Access Compliance Report

Public Rights-of-Way

Intersection ID: N/A	Main Street: STEELE_CREEK_RD	Cross Street: RACHEL_FREEMAN_WY	Location: NW
ADA ID: F88FED776710	Ramp Type: PerpDiag	Initial Pass/Fail: Fail	Overall Compliance: No
Severity Score: 12.5			
Codes/Mitigation Info/Possible Solution		Field Measurements/Component Compliance

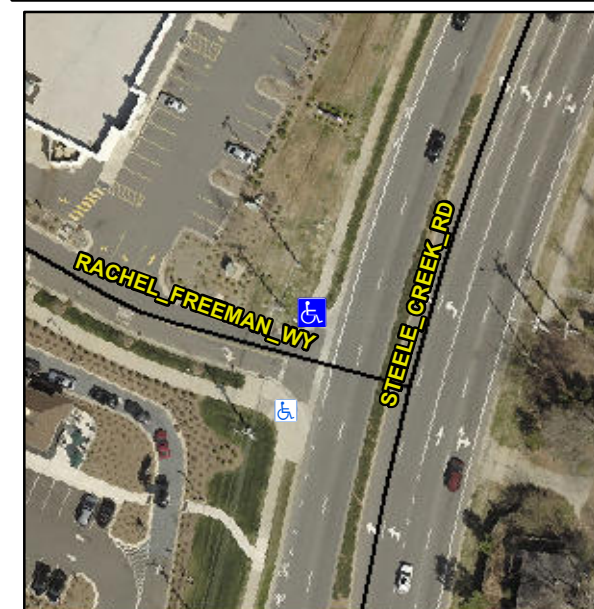
Not Found, R304.5.3

Compliance	Description	Data	Compliance	Description	Data
N/A	Ramp Length (in)	71.0	Yes	Ramp Slope (%)	7.8
Yes	Ramp Width (in)	48.0	No	Ramp XSlope (%)	5.5
N/A	Flare Type LT	N/A	N/A	Flare Type RT	N/A
N/A	Flare Slope LT (%)	N/A	N/A	Flare Slope RT (%)	N/A
N/A	Flare Traversable LT?	N/A	N/A	Flare Traversable RT?	N/A
N/A	Landing Length (in)	N/A	N/A	DWS Provided?	N/A
N/A	Landing Width (in)	N/A	N/A	DWS Contrast?	N/A
N/A	Landing Slope (%)	N/A	N/A	DWS Length (in)	N/A
N/A	Landing X Slope (%)	N/A	N/A	DWS Full Width?	N/A
N/A	Landing Curb? (Y/N)	N/A	N/A	DWS Offset (in)	N/A
N/A	Shared Landing?	N/A			
N/A	Gutter Ponding?	N/A	N/A	Gutter Slope (%)	N/A
N/A	Gutter Lip Ht (in)	N/A	N/A	Gutter X Slope (%)	N/A
N/A	Painted X Walk1?	No	N/A	Painted X Walk2?	No
	X Walk 1 Direction	To SW		X Walk 2 Direction	To SE
N/A	X Walk 1 Width (in)	N/A	N/A	X Walk 2 Width (in)	N/A
	X Walk 1 Slope (%)	1.8		X Walk 2 Slope (%)	0.3
	X Walk 1 X Slope (%)	3.5		X Walk 2 X Slope (%)	0.1

Remove & Replace Curb Ramp With Two New Directional Ramps or Equivalent.
